Agami Fashion Ltd.

No. H79/1, Chandra, Gazipur-1751, Bangladesh
(24.037616N, 90.254016E)
27th July 2016

ACCORD
on Fire and Building Safety in Bangladesh

Incomplete Structural drawing of Main factory building & Raw Materials Building

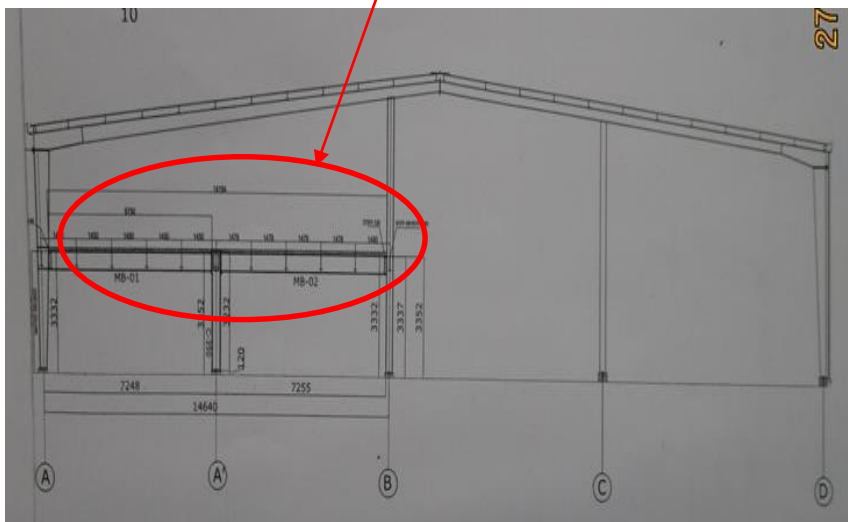
Different heightened mezzanine floor

No proper structural drawing was found for different heightened mezzanine floor

Observation: Main Factory Building

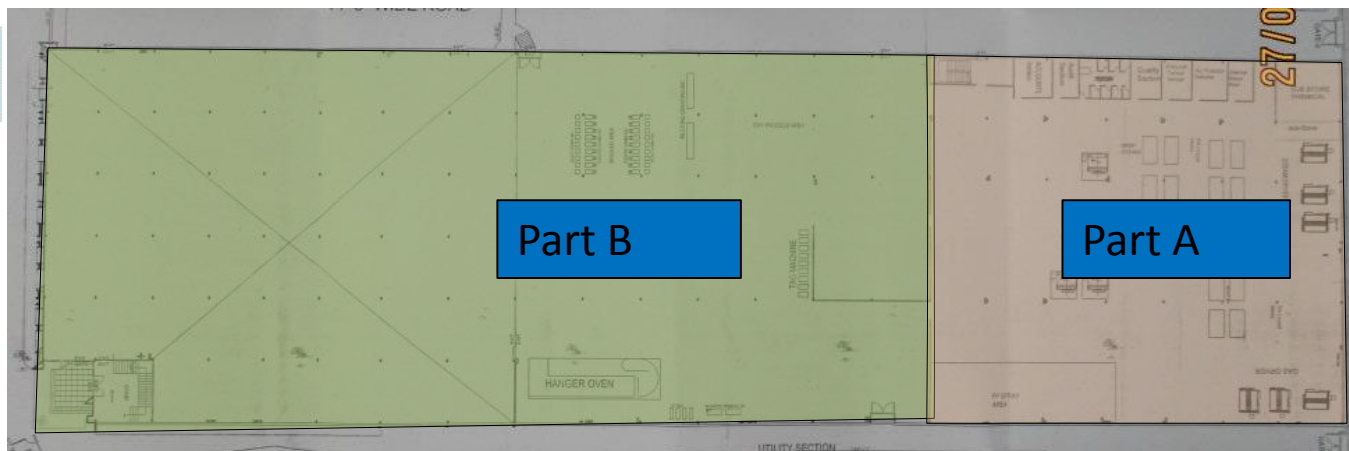
For the part A, no complete drawing was found. In addition with that, different dimension column steel member found on Part A portion.

Observation: Main Factory Building

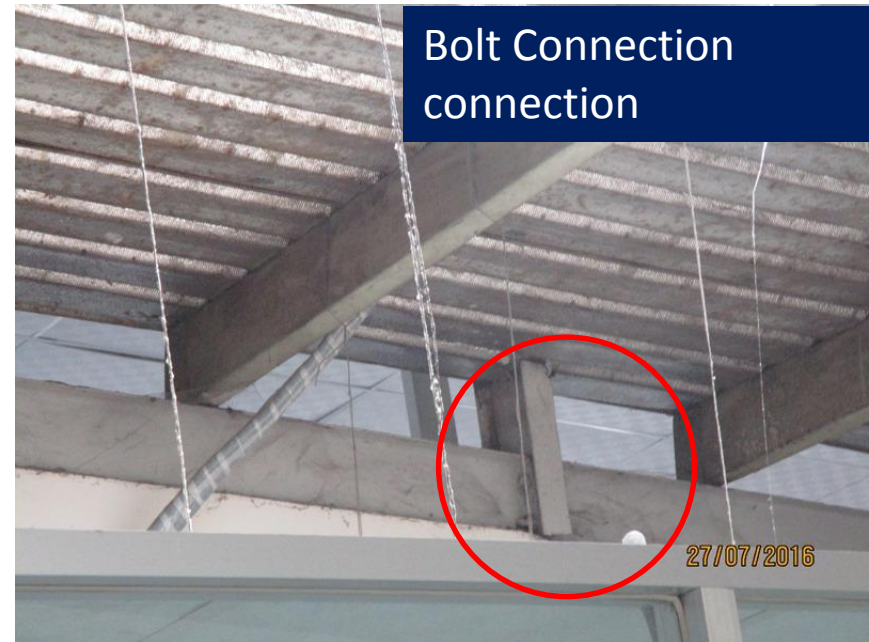
Vertical and horizontal bracing is not aligned.

Observed single bracing instead of cross bracing.

Observed faulty bracing

No proper bracing system was found in structural drawing.

Observation: Main Factory Building

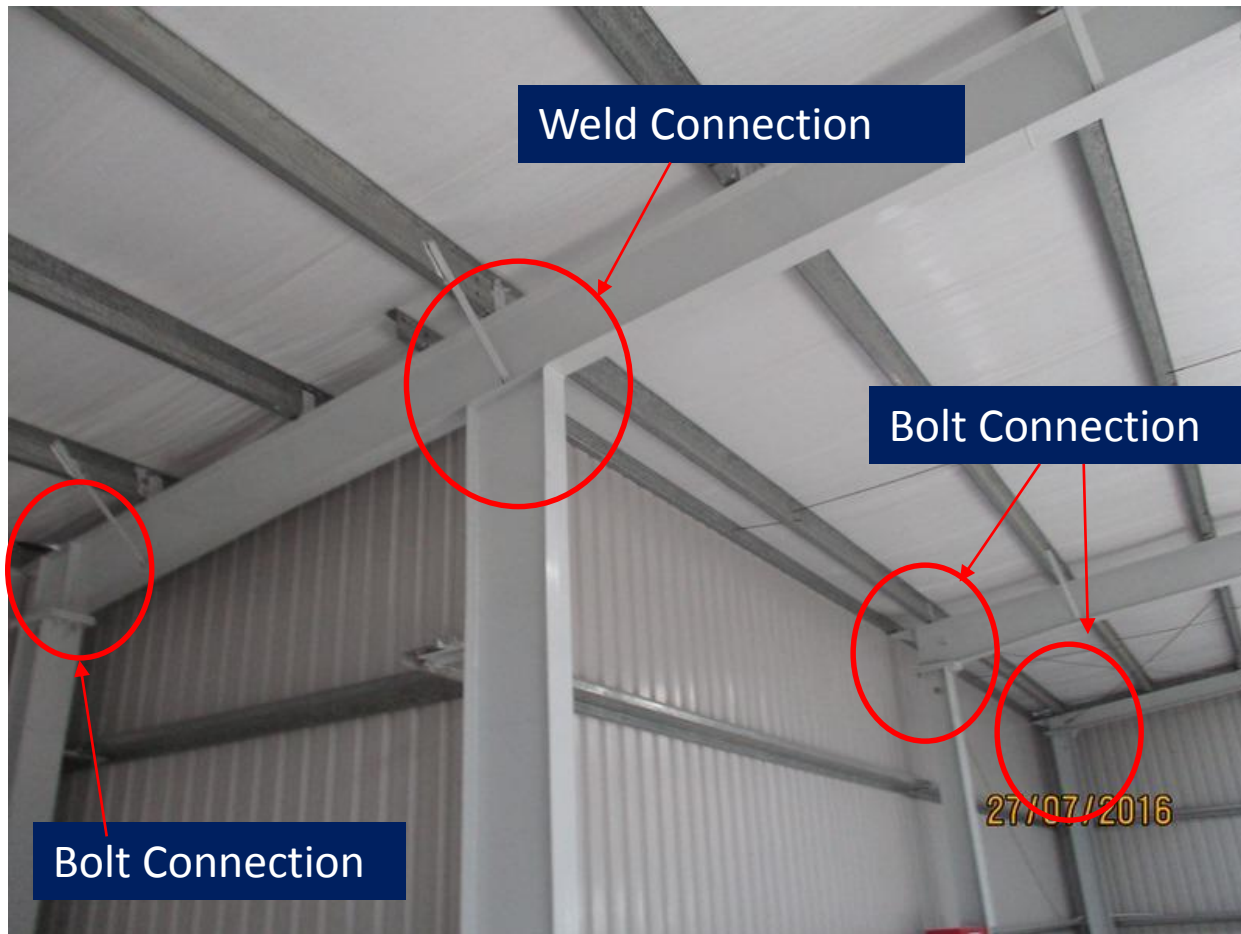
Some connection are Welded and some are Bolt connections

Some Rafters are connected with vertical member by weld and some are connected by bolt in Main Building

Some connection are Welded and some are Bolt connections

Absence of vertical Bracing in Structural drawing of Chemical Store & Raw Materials Building

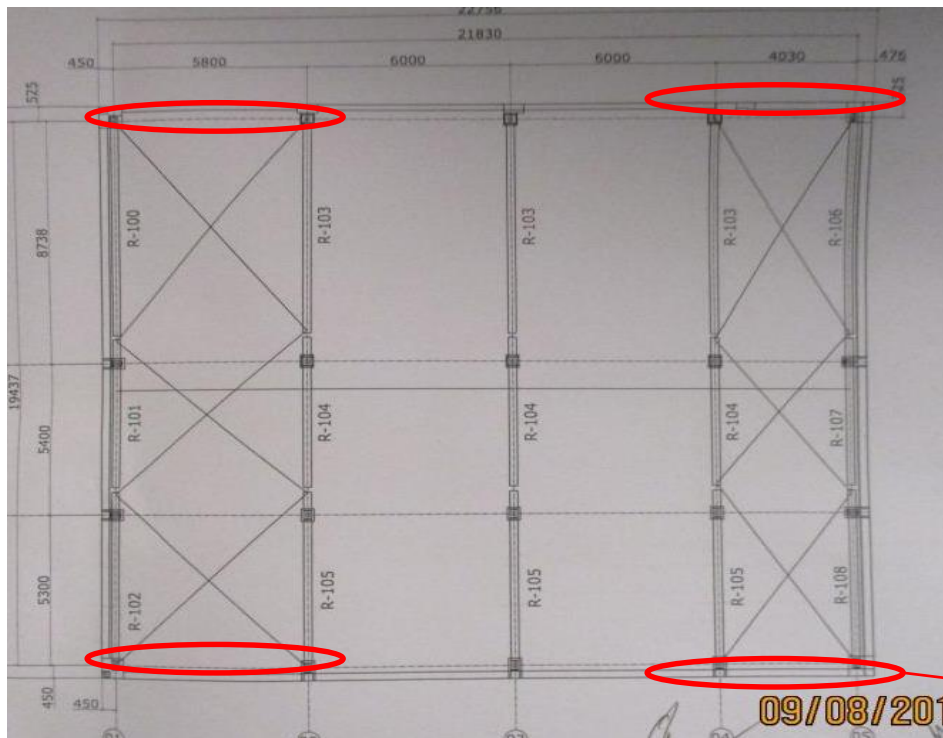
No vertical bracing system was find in structural drawing.

Vertical bracing

Observation: Chemical Store

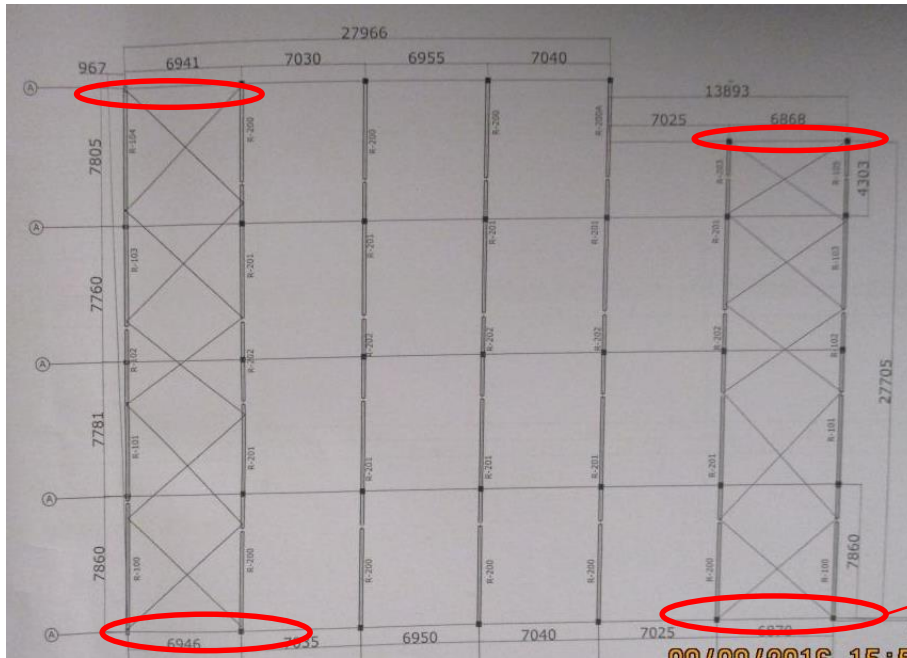
Vertical bracing

Discrepancy between drawing and as built condition Raw Materials Building

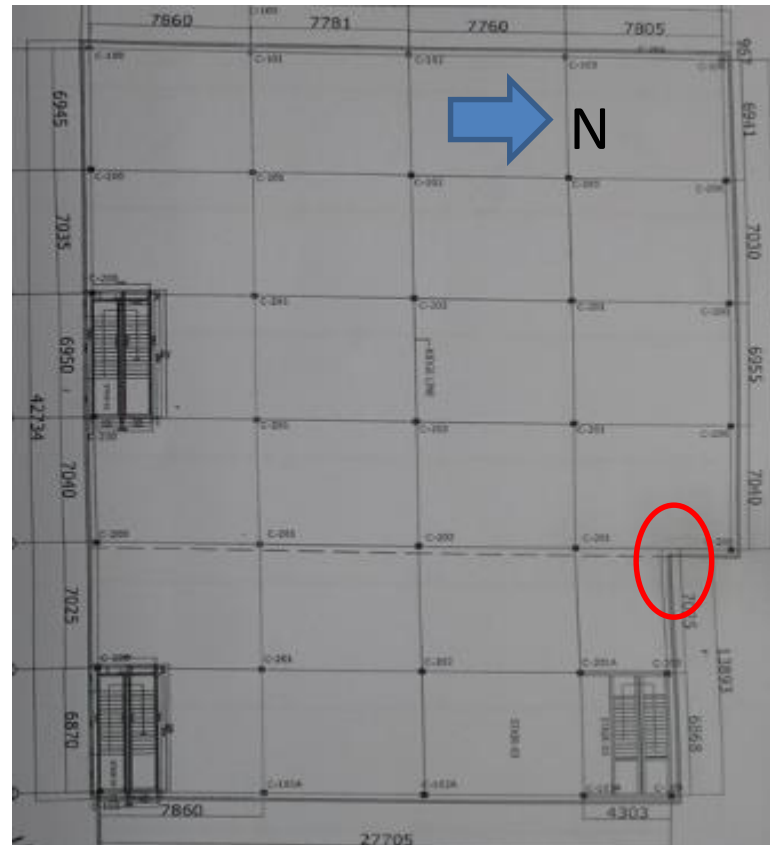
The marked column is not present in drawing. Noted that, the column is observed only on 1st floor.

5	Discrepancy between drawing and as built condition of Raw Materials Building	Carry out remedial works resulting from engineering assessment of building.	6-months
